**REMARKS**

Docket No.: S1022.80854US00  
Date: December 16, 2004  
x12/16/04x

Fig 2  
(prior art)

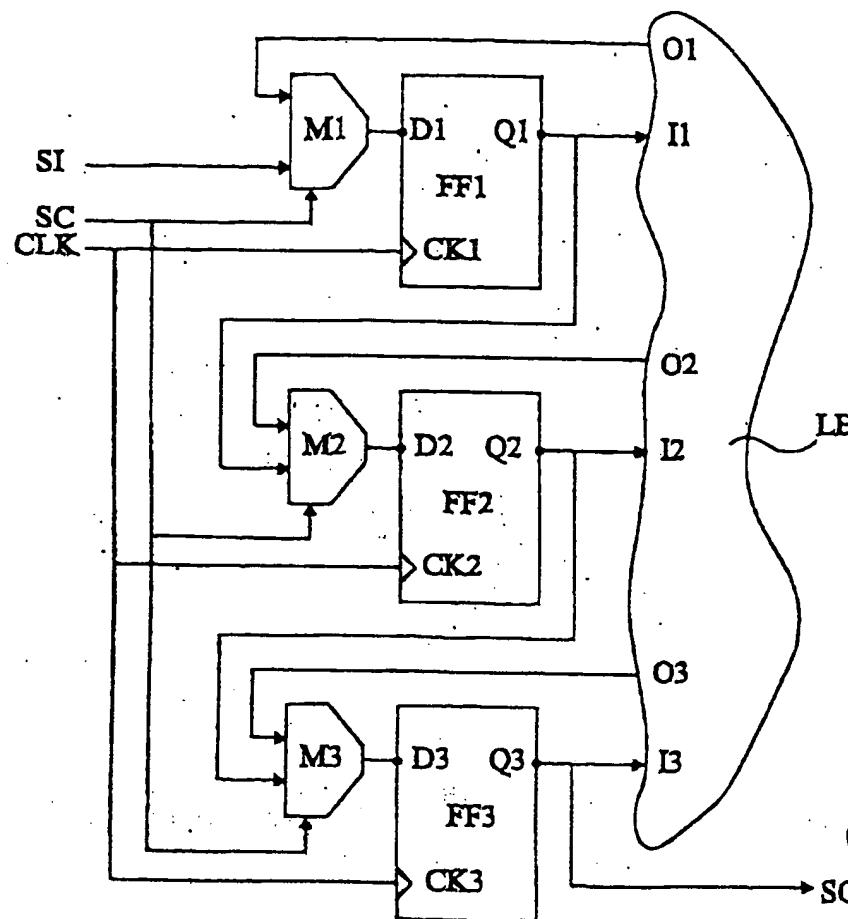
The Examiner objected to figures 1-3 for not being labeled as Prior Art. The Examiner has also objected to figures 3 and 4 for not having reference characters mentioned in the description. The label "Prior Art" has been added to figures 1-3. Reference "O5" has been added to figures 3 and 4. These changes correct obvious errors and do not add new matter. Accordingly, withdrawal of this objection is respectfully requested.

Fig 3  
(prior art)

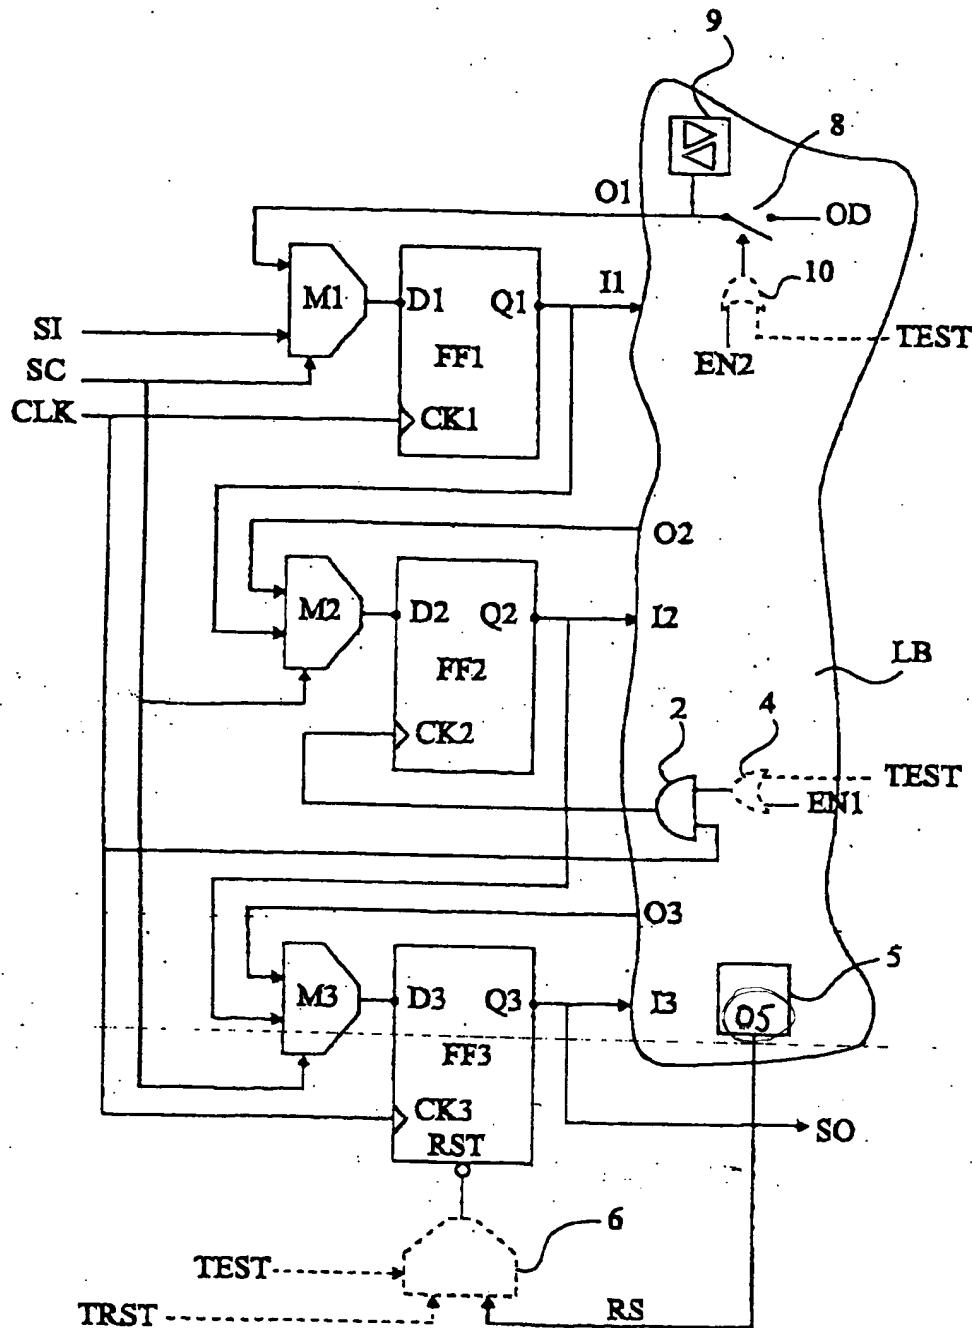
Applicants disagree that the prior art shows all of the claimed features. FIG. 3 of the present application shows a prior art circuit with disturbing elements such as 2, 5 and 8 all disabled by one signal, identified as “TEST.” The reference does not describe separate inhibition of disturbing elements or a controller that can generate control signals for that purpose.
